Subject: AP1000 Response to Request for Additional Information (SRP 3)

Response to Request for Additional Information on SRP Section 3

RAI Response Number: RAI-SRP3.7.1-SEB1-06
Revision: 5

RAI Response Number: RAI-SRP3.7.1-SEB1-17

Figure SRP 3.7.1-SEB1-17d-1 – Ni10 CIS FRS Comparison – CIS at RPV Support Elevation North/South Direction

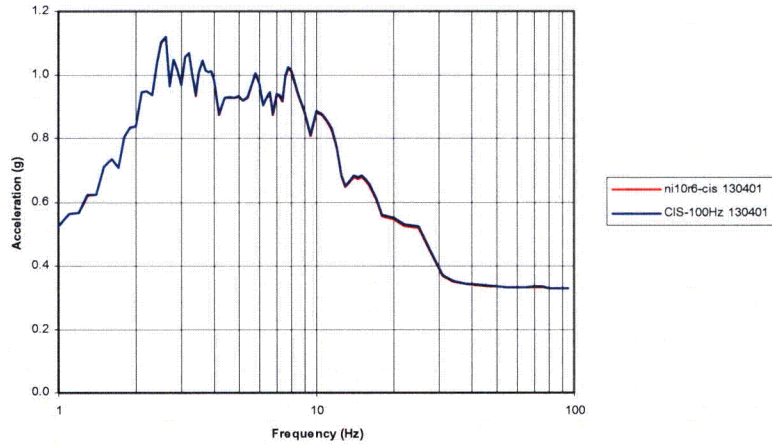
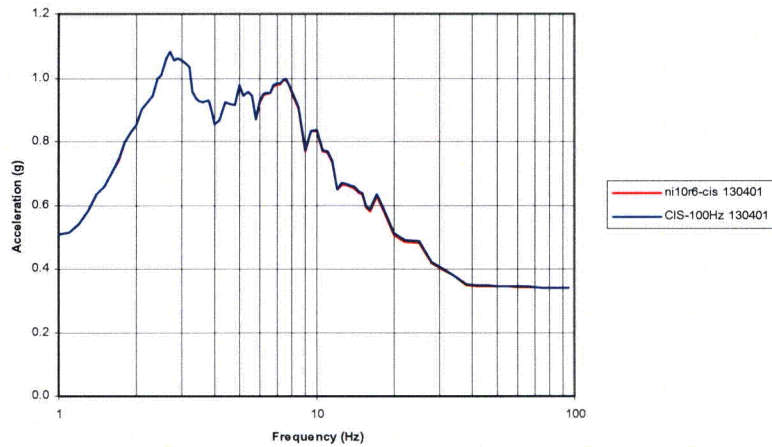
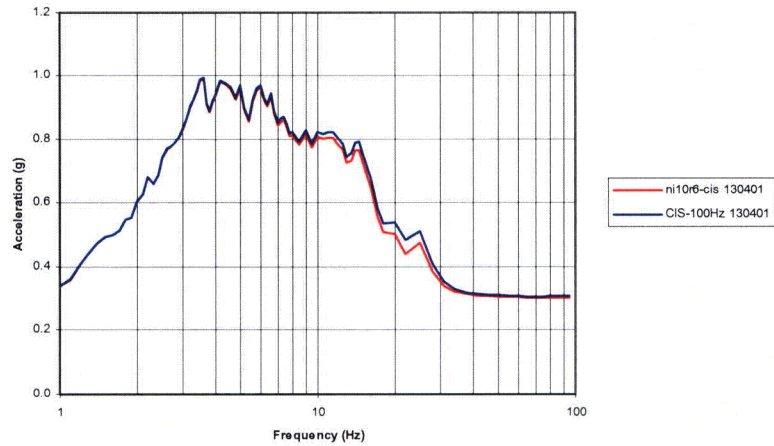
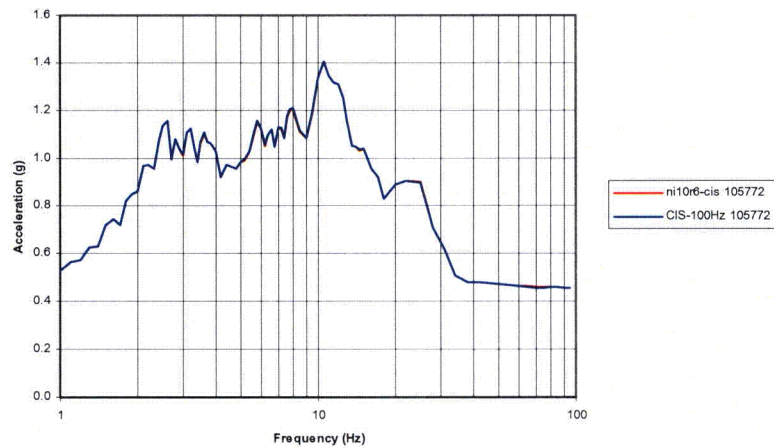
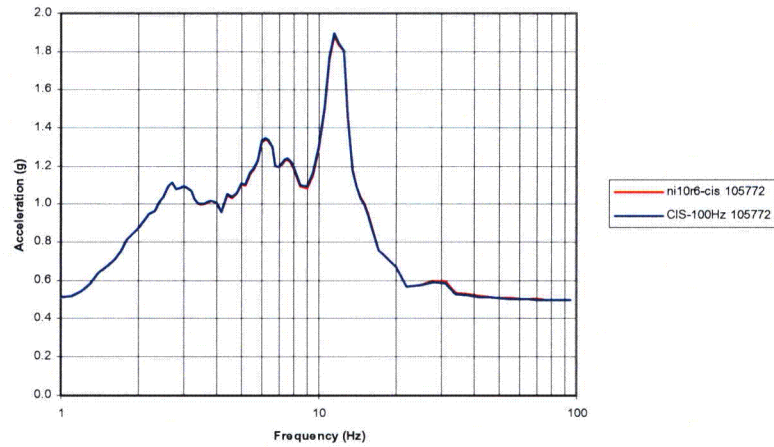
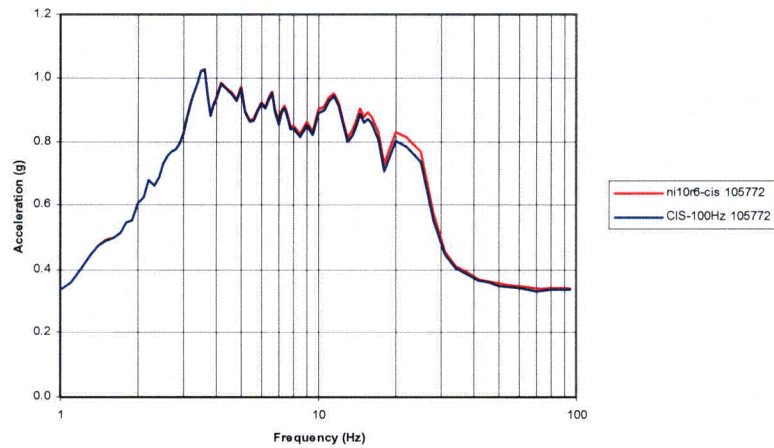
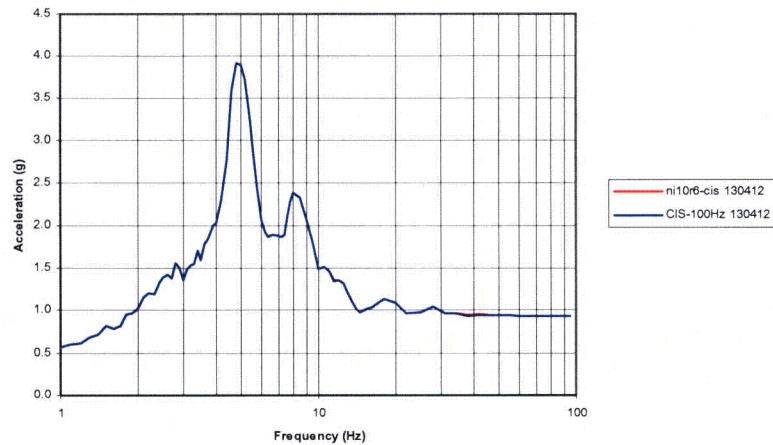
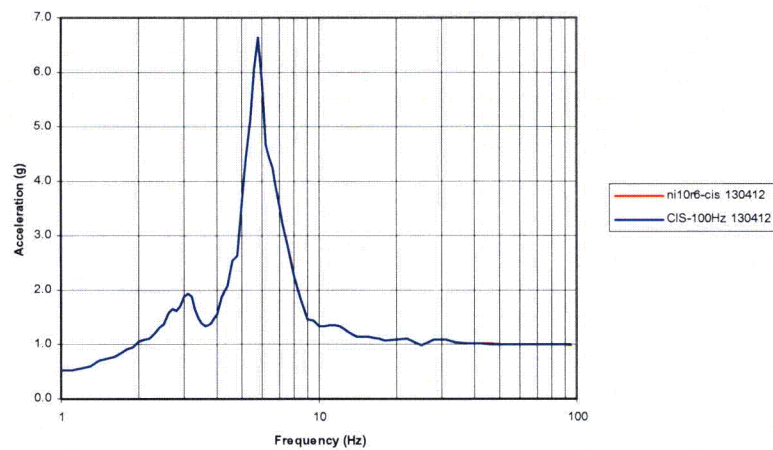
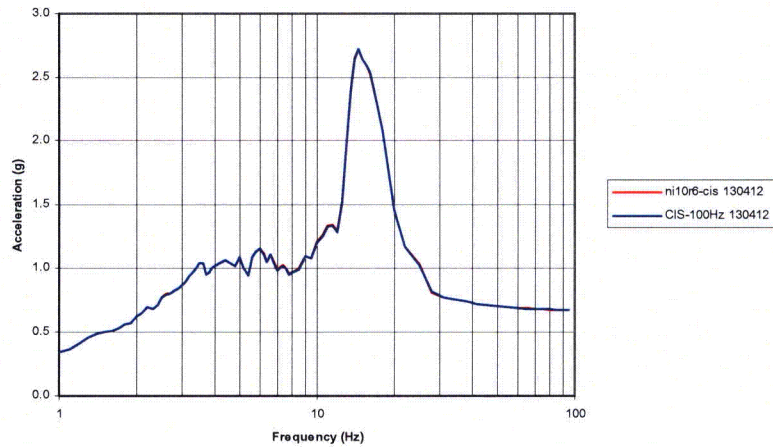
- (a) Top of page 10, specify figures -10 through -18, NOT -4 through -6.
- (b) Explain how the red and blue lines were plotted. There is no red on many of the figures.
- (c) Specify the seismic loading inputs for the NI10 analyses and for the NI05 analyses. They are different, and differences in response at the same location, between NI10 and NI05, are expected. This should be discussed to avoid confusion.
- (d) Discuss the difference in results in Figure -19.
- (e) Include the following information, discussed at the 3.7 audit:
 - (1) the method used to specify damping in the mode superposition time history analyses.
 - (2) the mode extraction method used in the mode superposition time history analyses.

In Figures SRP 3.7.1-SEB1-17d-1 through SRP 3.7.1-SEB1-17d-9 **ni10r6-cis (design basis)** represents the 45Hz time history analysis and **CIS-100Hz** represent the expanded mode analysis. In each figure, the design basis curve is plotted in red and the confirmatory analysis is plotted in blue. In curves where no red shows up, the confirmatory analysis matches the design basis exactly.
